THE PUBLIC UTILITIES COMMISSION OF OHIO

In the Matter of the Application of The Dayton Power and Light Company for Approval of Its Electric Security Plan)))	Case No. 08-1094-EL-SSO
In the Matter of the Application of The Dayton Power and Light Company for Approval of Revised Tariffs)))	Case No. 08-1095-EL-ATA
In the Matter of the Application of The Dayton Power and Light Company for Approval of Certain Accounting Authority Pursuant to Ohio Rev. Code § 4905.13))))	Case No. 08-1096-EL-AAM
In the Matter of the Application of The Dayton Power and Light Company for Approval of Its Amended Corporate Separation Plan))))	Case No. 08-1097-EL-UNC

Comments of the Staff of the
Public Utilities Commission of Ohio

December 15, 2009

Figure 1: Projected RPM Market Clearing Prices

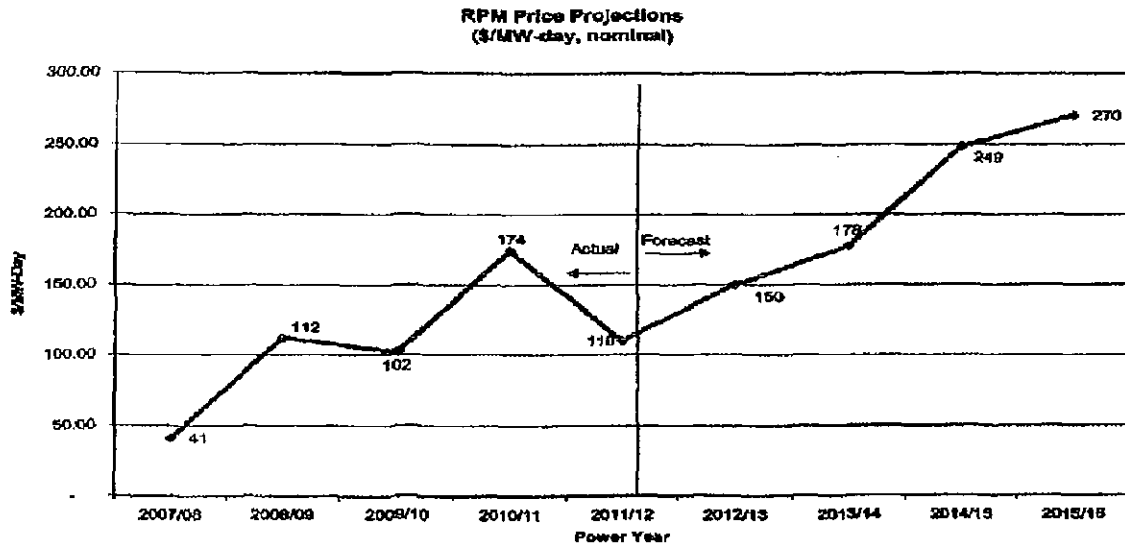
Figure 1 below is taken from the direct testimony of Scott W. Niemann of Charles River Associates. Ms. Marrinan’s valuation² approximately tracks the values in Figure 1. They are interpolated to accommodate the need for annual values however the trend line of values used to calculate the value of avoided capacity tracks the graphed values. For example, the calculations of benefits associated with AMI dependent CCEM programs and 3rd party curtailment made by witness Kevin Hall are based upon the valuation data adopted by Ms. Marrinan and represented in Figure 1.³

The “actual vs. projected” cutoff line was arguably properly drawn for the original filing of this case. On August 4, 2009 the filing was revised however the chart was not updated to account for more recent information. In the interim another Base Residual Auction (BRA) was held by PJM.

“The 2012/13 Reliability Pricing Model (RPM) Base Residual Auction cleared 136,143.5 MW of unforced capacity in the RTO at a Resource Clearing Price of \$16.46/MW-day. ... The \$16.46/MW-day RTO resource clearing price represents a decrease of \$93.54/MW-day from the 2011/2012 BRA. The RPM auction price was lower because of a growth in the available capacity and a decline in demand.”⁴

The company’s valuation of 2012/2013 capacity exceeds the actual by a factor of almost 10. Due to the severity of price decline in 2011/2012 and given the apparent ongoing supply and demand balance in PJM, subsequent years’ projections are also suspect. The results of the 2011/2012 BRA were known at the time of the revised filings in this case, and the prices used to value capacity should have been also revised.

These inflated capacity values tend to overstate customer benefits associated with demand reduction. Staff believes the revisions will reduce the value of programs by reducing the value of avoided capacity. We recommend the company revise its estimates and recalculate the benefits accordingly.
